Technical Car Construction Regulations

Changes for 2018 and Beyond

Version 2.0 (Published) – 27th November 2017

Rear Axle**(New) Differential**

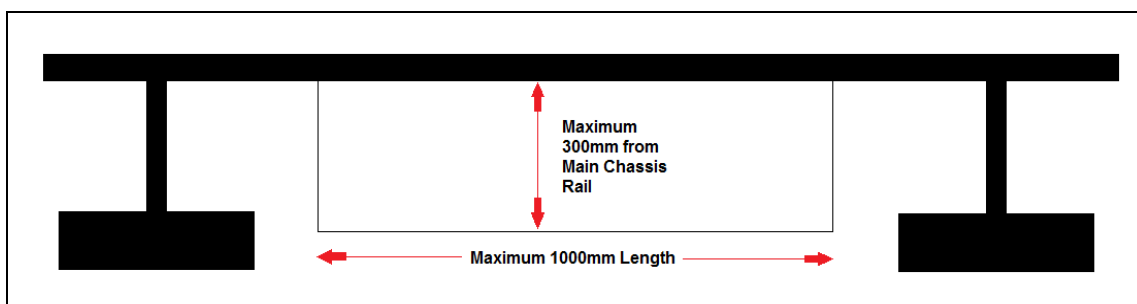
- Rule 210.6.2 will be changed, for safety, to state that the differential **MUST NOT** be able to contact the driver's seat if the rear shock absorbers are disconnected, or at their maximum compression.
- It **IS** permitted to add additional material (e.g. a piece of RHS, a dense rubber block) to the underside of the chassis rail, or the top of the axle casing, to ensure the differential does not contact the seat.

Bumpers / Nerf-Rails**(24.) Bumper Blades**

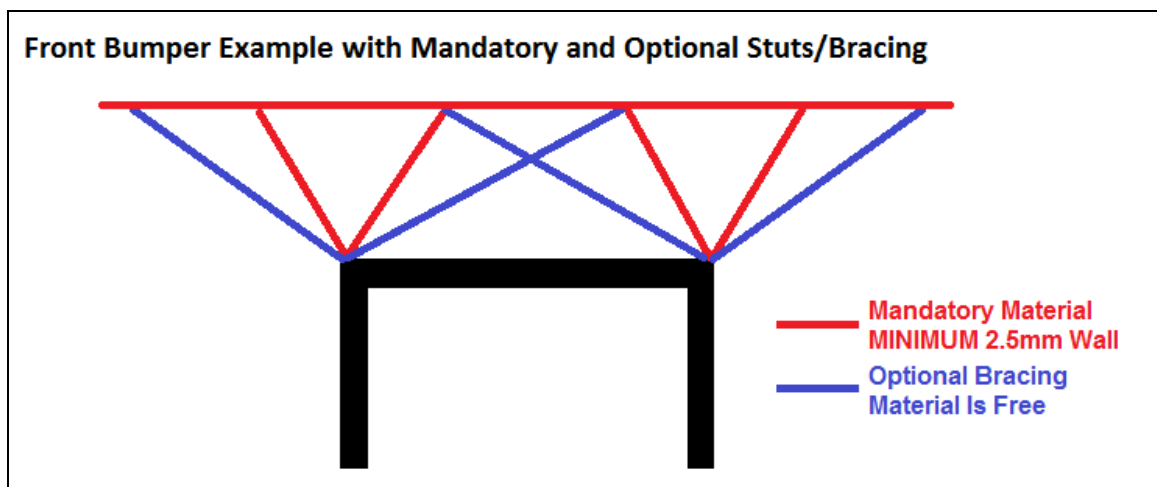
- Bumper blades (front and rear) MUST be constructed from material with a MINIMUM wall thickness of 2.5mm, e.g. 50mm x 25mm x 2.5mm RHS, or 25mm x 25mm x 2.5mm SHS.

**(28.) Nerf-Rails Outer Section (Blade) (2)**

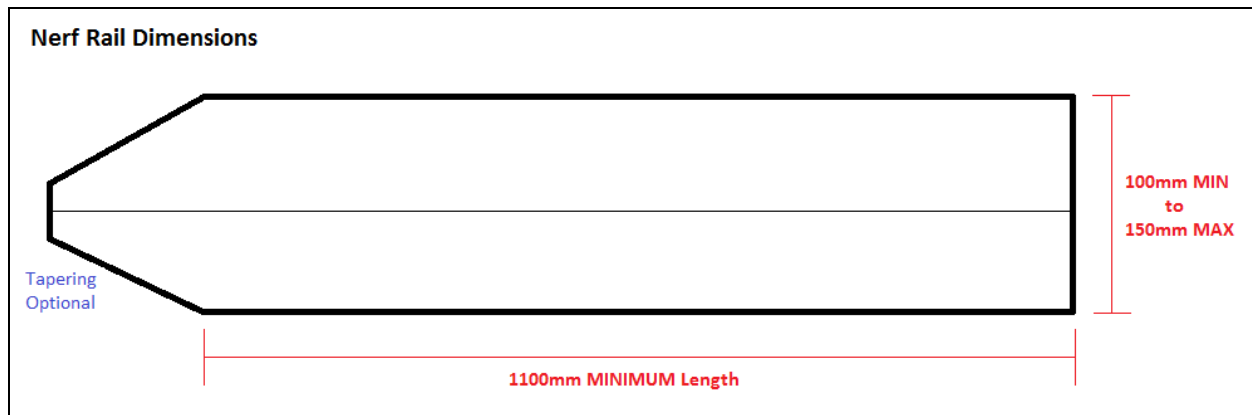
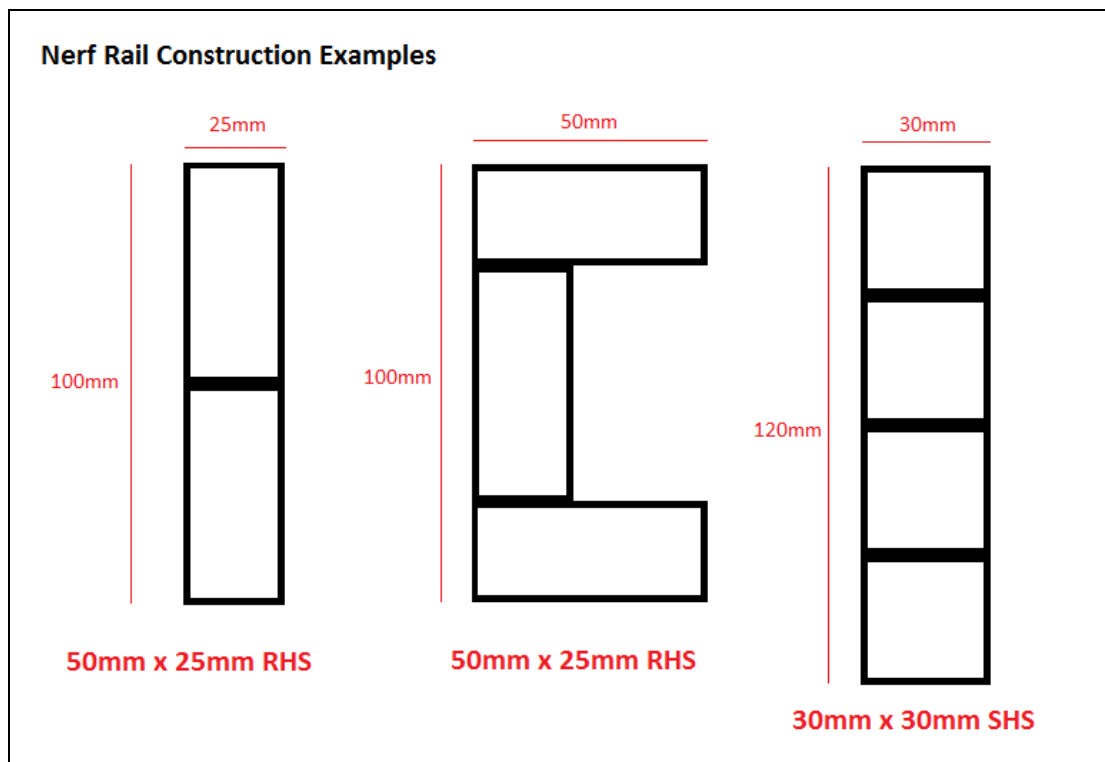
- The nerf-rails MUST be constructed with an outer “blade” configuration similar in appearance to the front and rear bumpers (subject to dimensions specified below).

- The nerf-rail outer blades MUST be constructed from a MINIMUM material specification of 50mm x 25mm x 2.5mm wall RHS, or 30mm SHS. The use of CHS in the construction of nerf-rail blades is NOT permitted.

- The lengths of SHS/RHS must be welded together to form a vertical “blade” with a flat outer face, subject to the min/max dimensions specified below.
- Nerf-rail blades MUST be no smaller than a MINIMUM of 25mm in thickness, and 100mm in depth.

- Nerf-rails blades MUST be no larger than a MAXIMUM of 50mm in thickness, and 150mm in depth.
- Nerf-rails blades MUST run for a MINIMUM length of 1100mm, from front to rear, at the minimum depth specified above (see diagram below).

- Tapering the ends of the nerf-rail blades is permitted, but the tapering must NOT form part of the minimum 1100x100mm specification. Sharp-pointed tapers are NOT permitted.

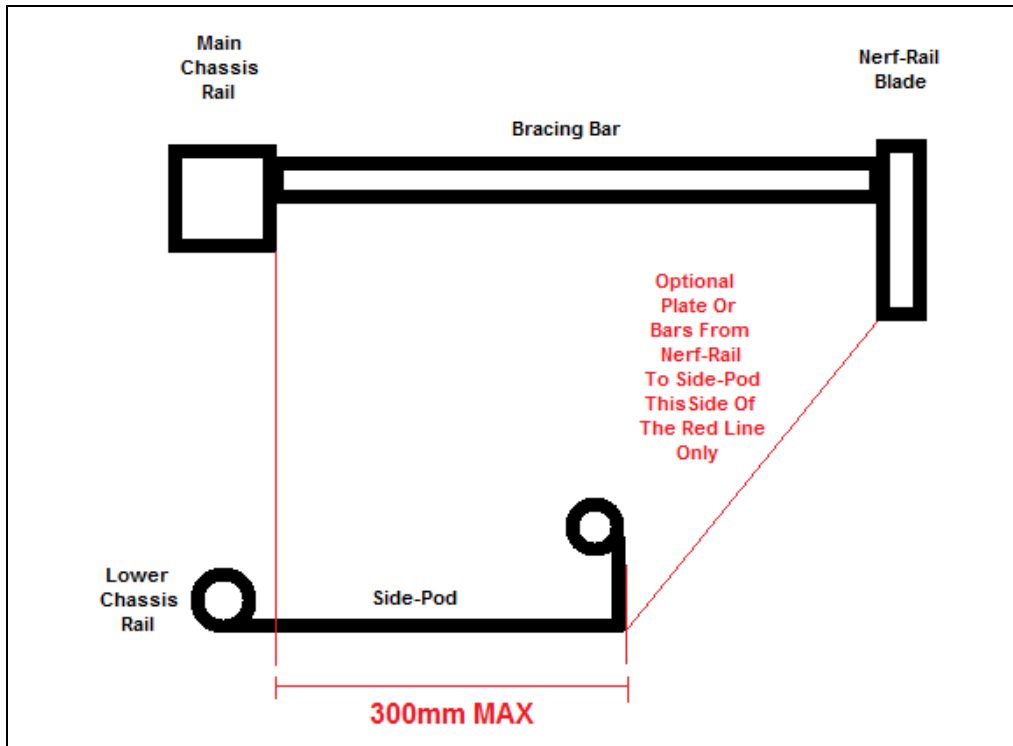
- Any additional optional material attached to the nerf-rail, e.g. a fuel tank protection plate or protection bars, must only be constructed within an area bordered by the main/lower chassis rails, the side-pod, the nerf-rail, the nerf-rail bracing to the main chassis, and a straight line linking the lower outermost point of the side-pod to the lower innermost point of the nerf-rail (see diagram below).

(29.) Nerf-Rail Bracing To Main Chassis

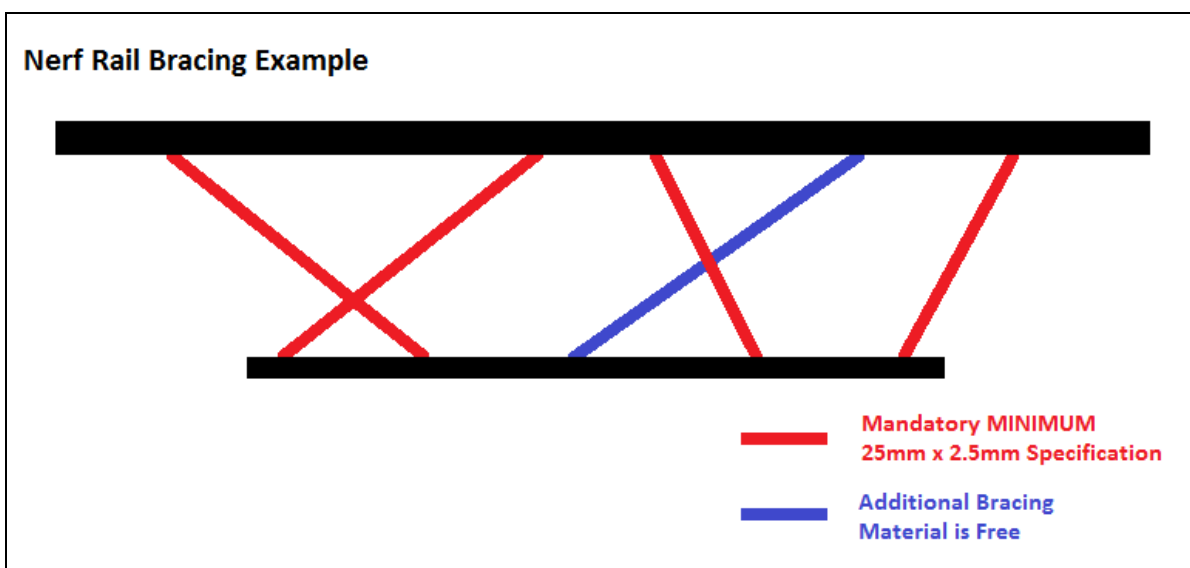
- The nerf rails MUST be connected/braced to the main chassis rails, by a MINIMUM of 4 braces on each side of the car, each of the 4 with a MINIMUM material specification of 25mm CHS/SHS x 2.5mm wall thickness.
- It IS permitted for the 4 mandated braces to cross.
- Additional nerf-rail to main chassis-rail bracing (over and above the 4 mandated braces) is free in both quantity and material specification.
- The lightening of the nerf-rail braces, or the drilling of holes in them, is NOT permitted.

New Update Engine Offset

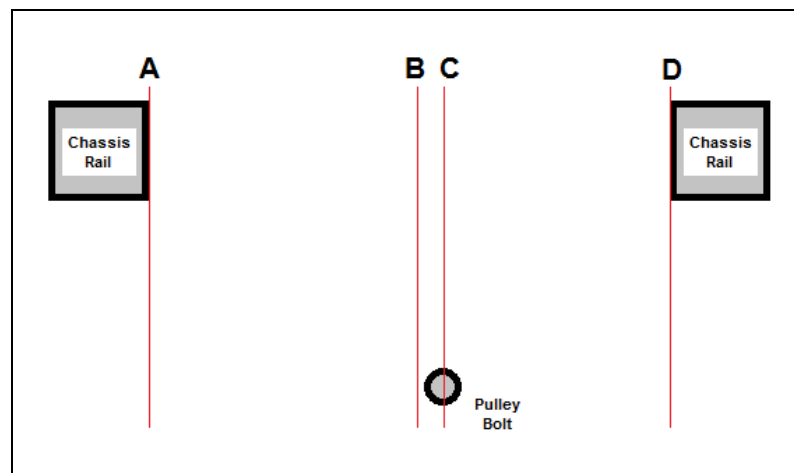
- A diagram will be included in the rulebook to clarify the method of measurement for engine offset (similar to below).
- The existing wording will be updated to specify that...

- Measurement is to be taken horizontally from the vertical plane of the centre of the crank pulley bolt (C) to the vertical plane of the inner edge of each chassis rail (A) and (D) when the chassis is sat level. *[These planes will only be vertical if the chassis is sat level, so raising up one side of the chassis to make the chassis rails level may be required. Alternatively measurements can be taken using a square/straight-edge, from a straight-edge placed across the chassis rails, thus removing the effect of the ground/surface not being level.]*

- The two measurements (C to D, and C to A, in the example diagram below) MUST NOT differ by more than 50mm.
 - Halving the difference between the two measurements (C to D, and C to A in the diagram below) will give the offset from the vertical plane of the centreline of the chassis (C to B).

- The distance from the centreline of the chassis to the centre of the crank pulley bolt MUST NOT be more than 25mm.

(4.) Ballast (1)

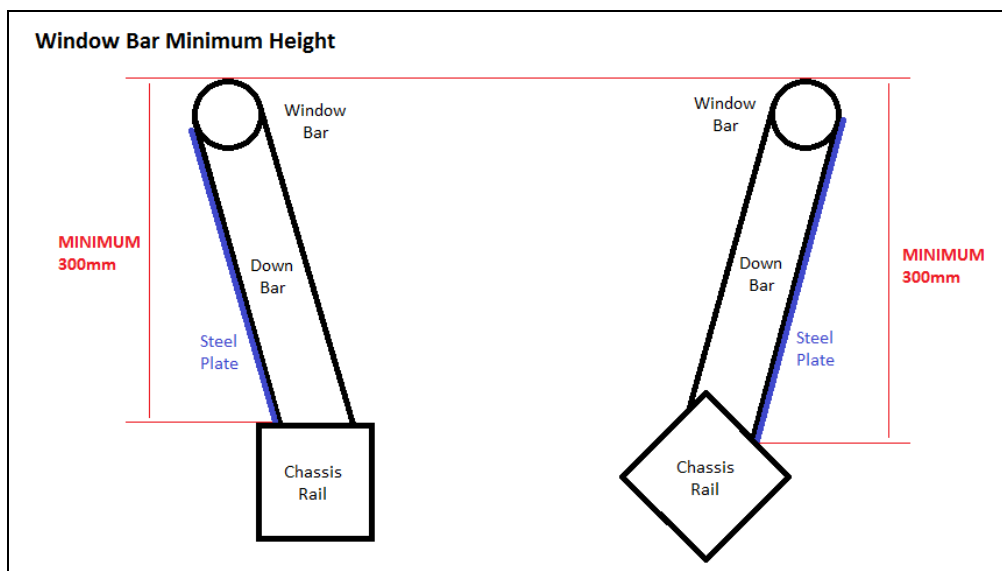
- The **MAXIMUM** permitted steel plate thickness, in **ANY** part of the car, will be reduced to a **MAXIMUM of 3mm** (unless specifically permitted elsewhere in the rules, e.g. the cab floor).
- This change will cover plate such as the side-pods, fuel protection, and cab sides/rear.
- This change will **NOT** include plate used in the construction of items such as wishbone brackets or rear-axle link bar mounting brackets.
- The “stacking” of more than two lengths of tube (e.g. RHS, SHS, CHS) in the construction of the chassis, side-pod, fuel-tank/battery protection, or other parts of the car will be reviewed during 2018, with limitations potentially being put in place for 2019, e.g. a minimum gap between tubes.

(15.) Roll-cage Plating – (in conjunction with 11. above)

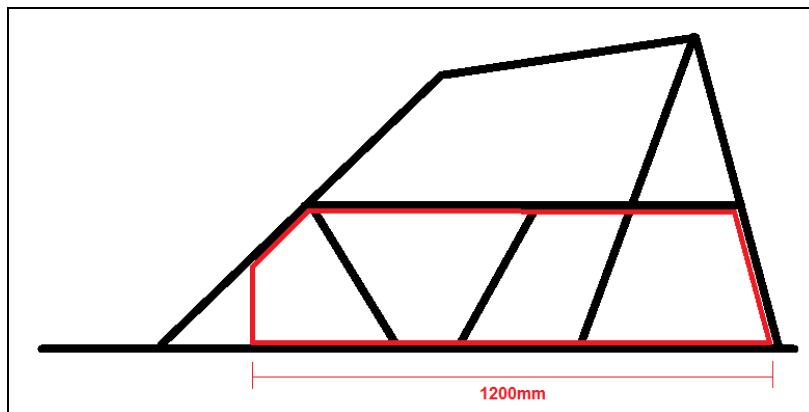
- BOTH sides of the roll-cage MUST be plated in steel plate (with a MINIMUM thickness of 2mm) to fully enclose the area bordered by the main chassis rail, the rear roll-cage pillar, the side window bar, and the front roll-cage pillar (or an additional down-bar as necessary to meet dimensional requirements).

- The plate MUST be fitted as either a single piece (formed as required), or up to a MAXIMUM of 3 pieces on each side of the car (for easier fitment on non-flat cab sides).

- The plate MUST be fitted to the outside of the roll-cage/window-bar/down-bars, or inset NO MORE than a MAXIMUM of 5mm from the outer edge of the tube.

- The plate (each plate section) MUST be fully welded to the roll-cage structure along the full length of each of its sides (in the same manner as the existing rear panel).

- The area covered by the plate MUST measure at least a MINIMUM of 1200mm in length, from the rearmost point where the rear roll-cage pillar meets the chassis rail, horizontally, to the vertical plane where its front-most point meets the chassis rail.
